Dynamic Site Investigation and Summary Remedial Investigation Report Lockheed Martin Corporation, Beaumont Site 2 Beaumont, California

Subject: Submittal of the final Dynamic Site Investigation Report, Beaumont Site 2

RESPONSES TO COMMENTS ON THE DYNAMIC SITE INVESTIGATION REPORT, LOCKHEED MARTIN CORPORATION, BEAUMONT SITE 2, BEAUMONT, CALIFORNIA

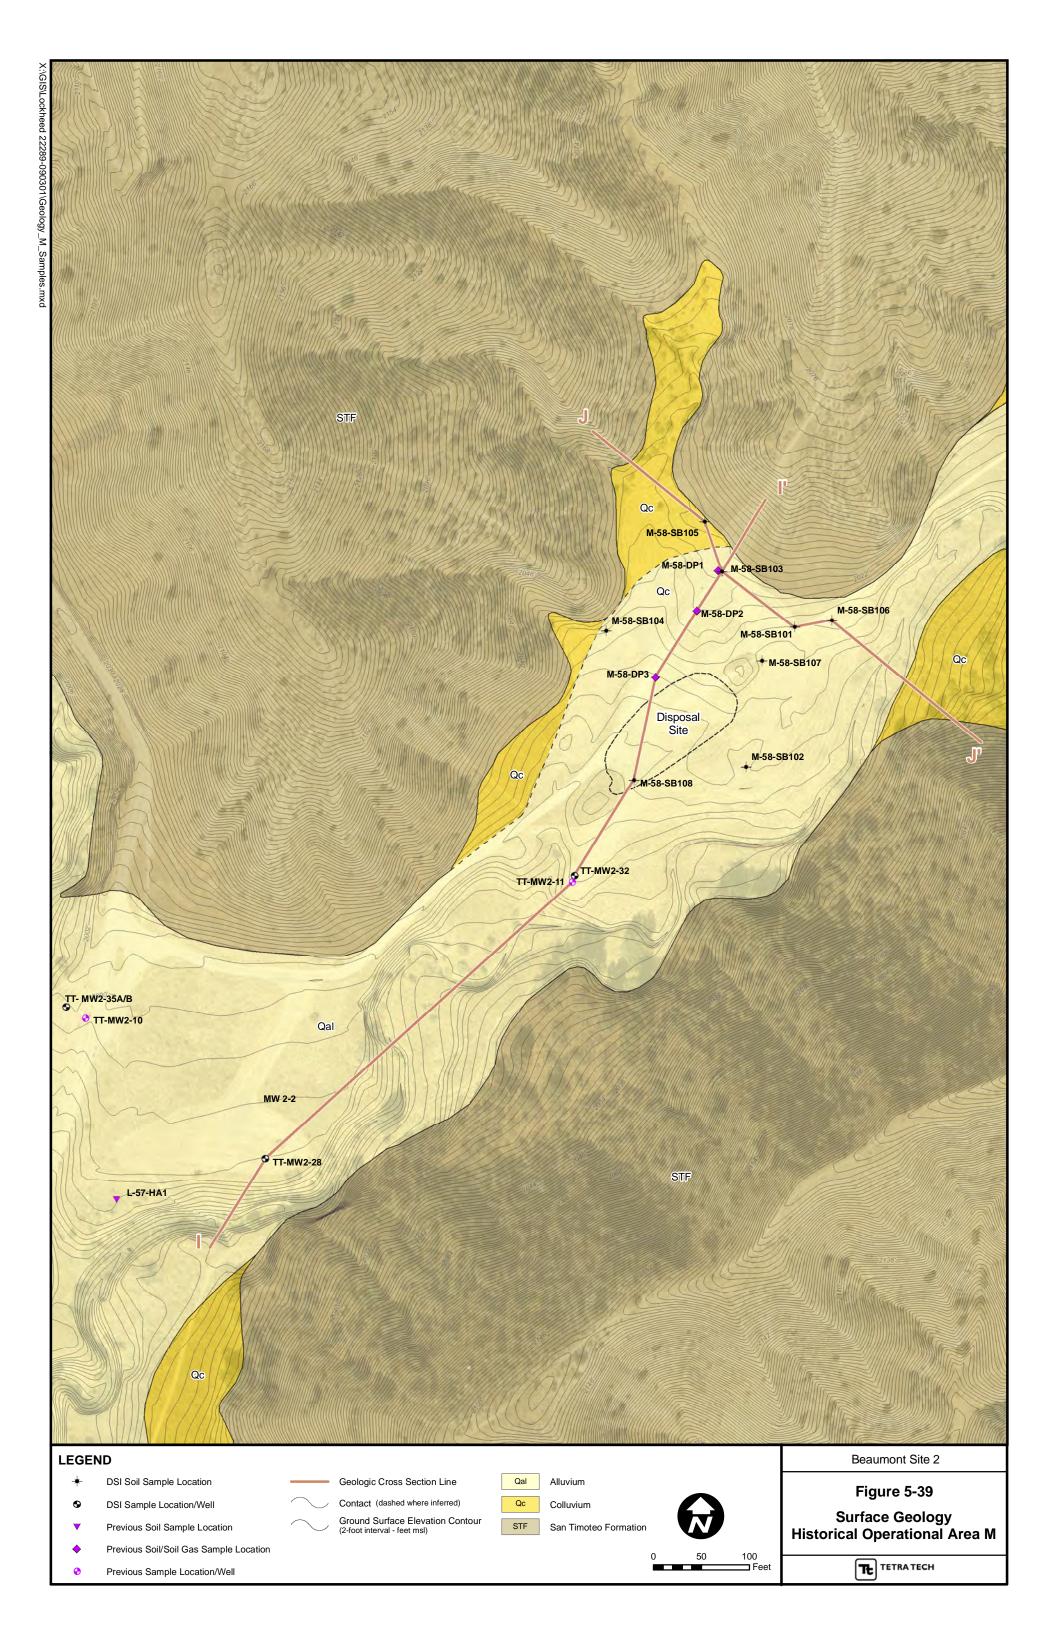
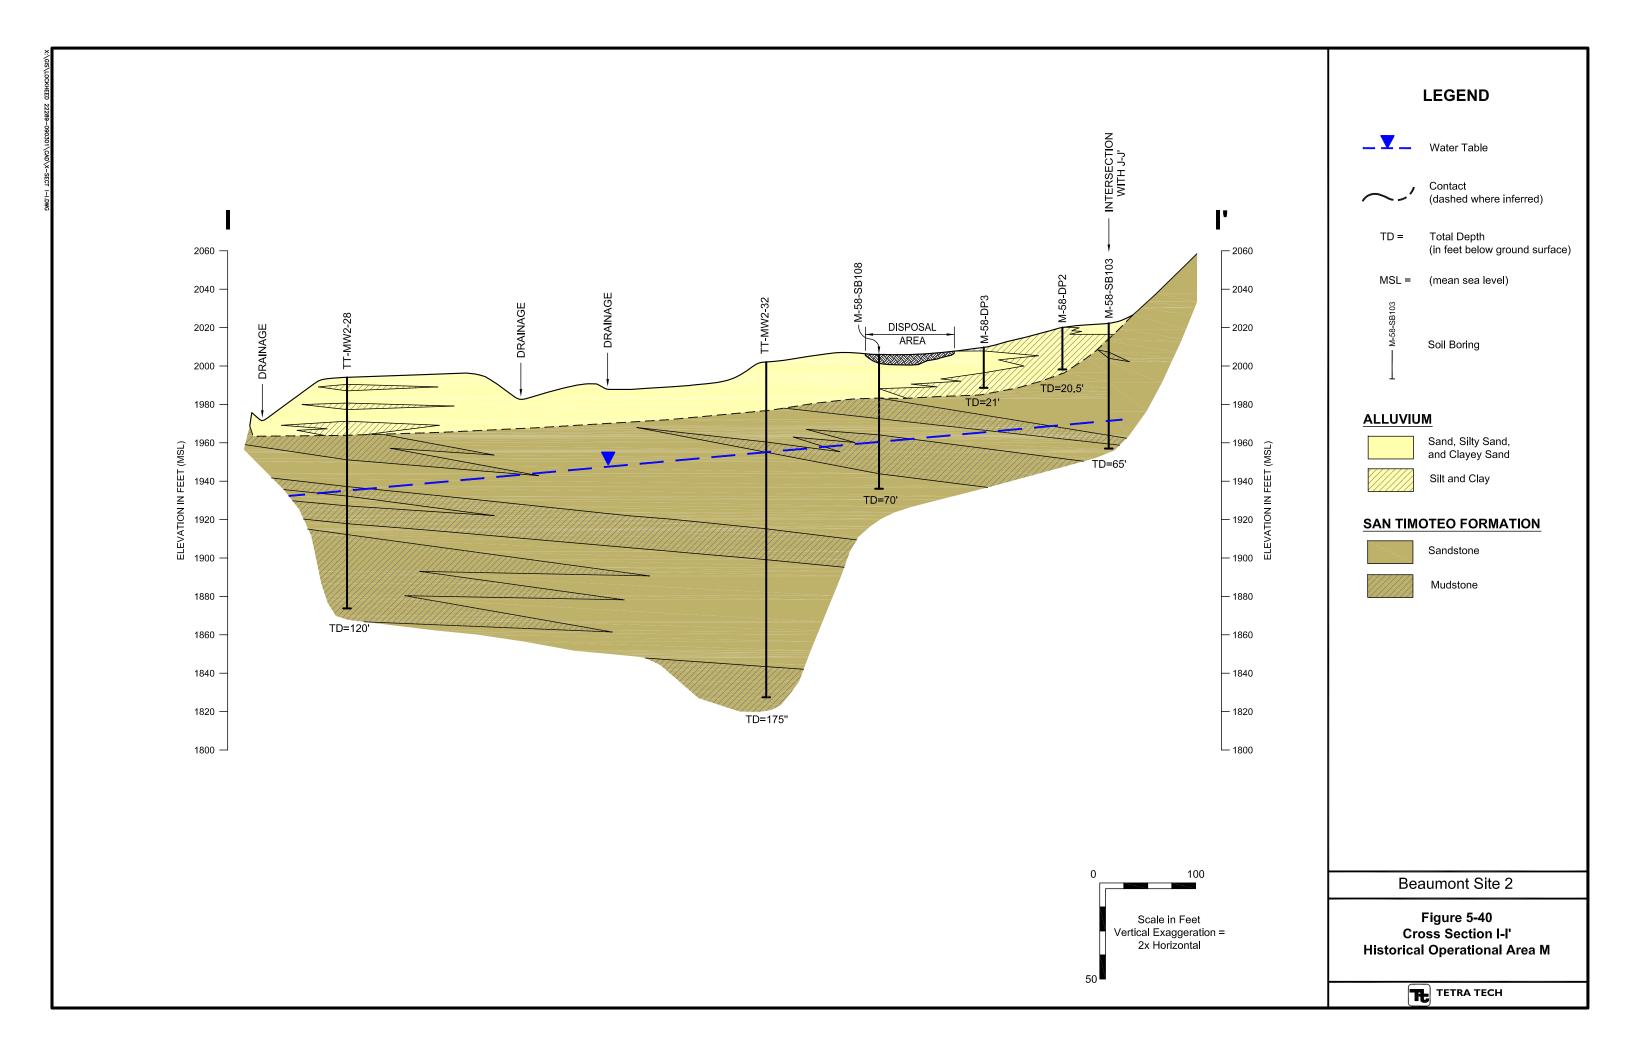
Comments f	Comments from Dina Kourda, DTSC GSU	
Comment	Response	Proposed Action
Specific Comment 8. Figures 5-40 (I-I') and 5-41 (J-J'): The intersections are not congruent on respective figures and should be corrected.	Comment noted.	Figures 5-40 and 5-41 will be revised so that the cross-sections match at their intersection.
Specific Comment 9. Figure 5-47: Soil boring SB-6 should be identified on this figure.	Soil boring SB6 was completed as well TT-MW2-24. TT-MW2-24 is shown on Figure 5-47.	Figure 5-47 will be revised to indicate both boring and well designations where appropriate, including TT-MW2-24/SB6.
Minor Comment 1. Appendix D: The font should be checked on the title of each soil-gas diagram. The word, "Soil" appears as "Soll."	Comment noted.	The soil gas probe completion diagrams in Appendix D will be revised to clarify the spelling of "Soil."
